Technical note:

Additional Drainage Information to Outline Drainage Strategy

Earl Shilton, Leicestershire

This document has been prepared in response to the queries raised by Leicestershire County Council (LCC), as the Lead Local Flood Authority (LLFA) in relation to applications 21/01511/OUT and 23/00330/OUT. A copy of these responses is included in Appendix A.

Indicative Drainage Strategy Drawing

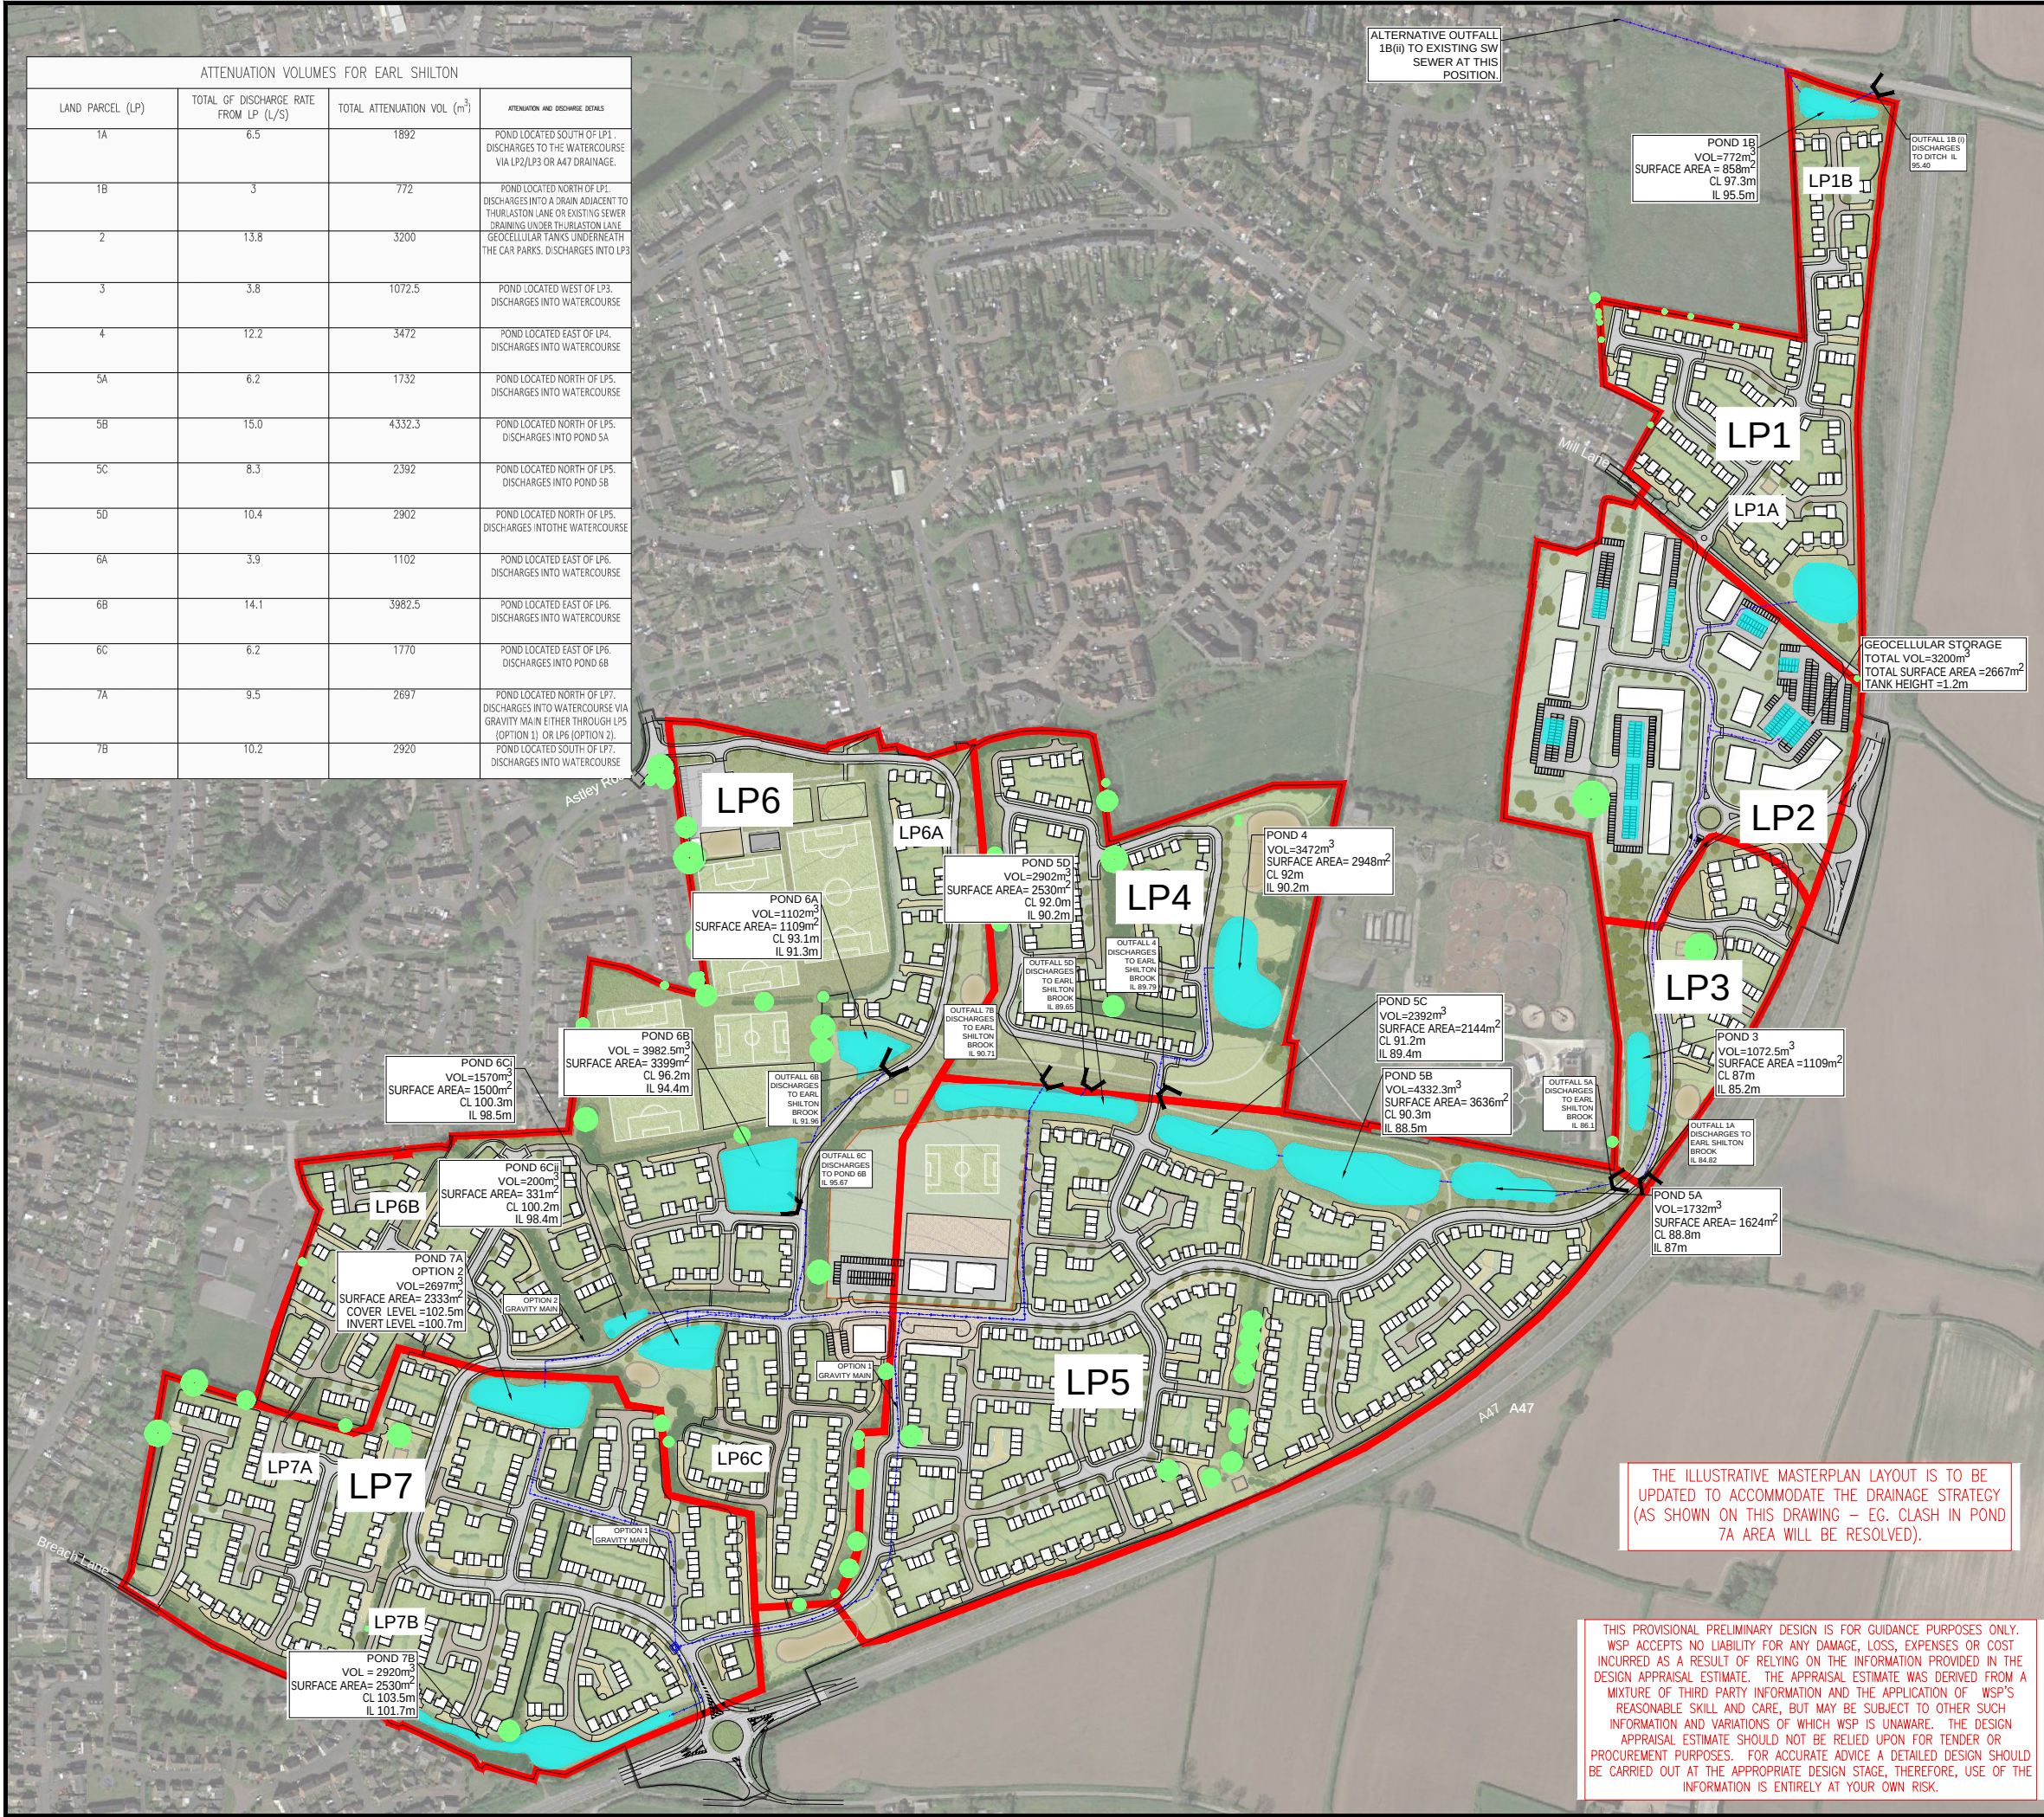
- A more detailed drainage strategy plan which details the site outfalls for each catchment in addition to baseline level detail in order to demonstrate that each catchment can drain as indicated. Levels should account for depth of the proposed basins and receptor invert levels.
- Existing surface water catchment plans which identify all surface water features on-site.
- Confirmation from the Environment Agency that the flood compensation proposals are acceptable.

- Appropriately detailed surface water drainage strategy plans for parts of the development within this specific application.
 - The plan should identify SuDS locations and outfalls for the application land parcels, with sufficient level detail to demonstrate viability. Outfall levels should be based on surveyed data. SuDS basins should show indicative depths.

The site has been divided into 7 land parcels, labelled Land Parcel 1 (LP1) to Land Parcel 7 (LP7). A more detailed revised drainage Strategy drawing as requested by LCC has been produced showing the location of the proposed SuDS components including outlets from these. This drawing is included in Appendix B.

The plan in Appendix B shows two Options for the SW drainage of pond 7A. Option 1 via LP5 or Option 2 via LP6.

However, an alternative route for the outfall from pond 7A is technical feasible through LP6 if desired. These routes are illustrated as Options 1 and 2 on the plan in Appendix B.
